RE: Parcel Map No. 2019-135

EXTENSION OF TIME

Re: AA-2019-135-PMLA-WDI
15010 W. Burbank Boulevard &
15009 W. Killion Street
Van Nuys-North Sherman Oaks Community Plan
Zone : [Q]R3-1, R1-1
D.M. : 174-B-145
C.D. : 4 -Ryu
CEQA : ENV-2019-137-CE
Legal Description: Fraction of Lot 365 (Arb 4);
Tract: 1000

PRELIMINARY PARCEL MAP

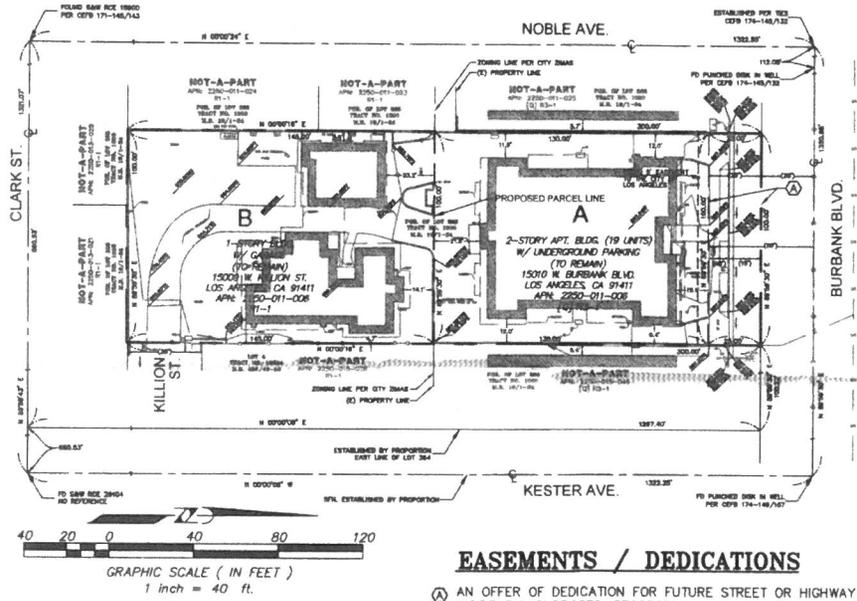
- c. The submitted plot plan is not complete. Provide a plot plan drawn to scale that accurately indicate the building sizes and required yards on the site. Indicate the number of stories, height, permitted use (attached or detached garage) and the type of construction for all buildings on the site. If attached garage, provide a 15 ft. rear yard setback or obtain approval from the Department of City Planning.

- e. The submitted Map does not comply with the maximum density (800 s.f. of lot area/dwelling unit) requirement of the [Q]R3-1 Zone. Revise the Map to show compliance with the above requirement or obtain approval from the Department of City Planning.
- f. Show all street dedication(s) as required by Bureau of Engineering and provide net lot area after all dedication. "Area" requirements shall be re-checked as per net lot area after street/alley dedication. Front yard requirements shall be required to comply with current code as measured from new property lines after dedication(s).

- (3) Approved herein for the single family lot (Parcel B) is a reduced rear yard setback of 14 feet-1 inch in lieu of 15 feet and a reduced east side yard setback of 4 feet, 7-inches in lieu of 5 feet otherwise required for the R1-1 Zone.
